Access Compliance Report Public Rights-of-Way (Curb Ramps)

Main Street: LA_COLINA_DR Cross Street: RANCHWOOD_RD Location: NE

ADA ID: RPRK220103124449 Ramp Type: Type 4 - Parallel Initial Pass/Fail: Fail Overall Compliance: No Severity Score: 2

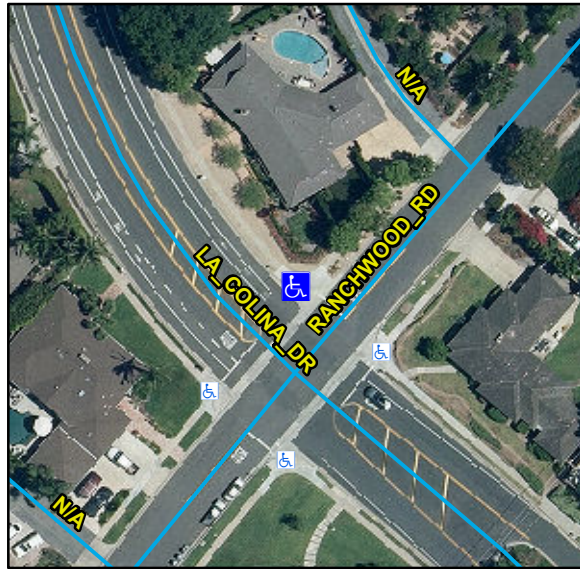
Compliance	Description	Data	Compliance	Description	Data
N/A	Ramp Length LT (in)	84	N/A	Ramp Length RT (in)	82
Yes	Ramp Width LT (in)	93	Yes	Ramp Width RT (in)	92
Yes	Ramp Run Slope LT (%)	4.1	Yes	Ramp Run Slope RT (%)	5.1
No	Ramp Cross Slope LT (%)	2.5	Yes	Ramp Cross Slope RT (%)	0.9
N/A	Landing Present	N/A	N/A	DWS Provided	N/A
N/A	Landing Length (in)	N/A	N/A	DWS Contrast	N/A
N/A	Landing Width (in)	N/A	N/A	DWS Length (in)	N/A
N/A	Landing Run Slope (%)	N/A	N/A	DWS Full Width	N/A
N/A	Landing Cross Slope (%)	N/A		DWS Offset Type	N/A
N/A	Landing Movement Obstructed?	N/A	N/A	DWS Offset Left (in)	N/A
	Landing Movement Type	N/A	N/A	DWS Offset Right (in)	N/A
N/A	Landing Shared	N/A			
N/A	Clear Space	Yes			
N/A	Clear Space To Crosswalk (in)	N/A			
N/A	Marked Crosswalk 1	No	N/A	Marked Crosswalk 2	No
	Crossing 1 Direction	SW		Crossing 2 Direction	SE
N/A	Marked Crosswalk 1 Width (in)	N/A		Marked Crosswalk 2 Width (in)	N/A

Remove & Replace Curb Ramp With Two New Directional Ramps or Equivalent.

R304.5.3, STD 1115
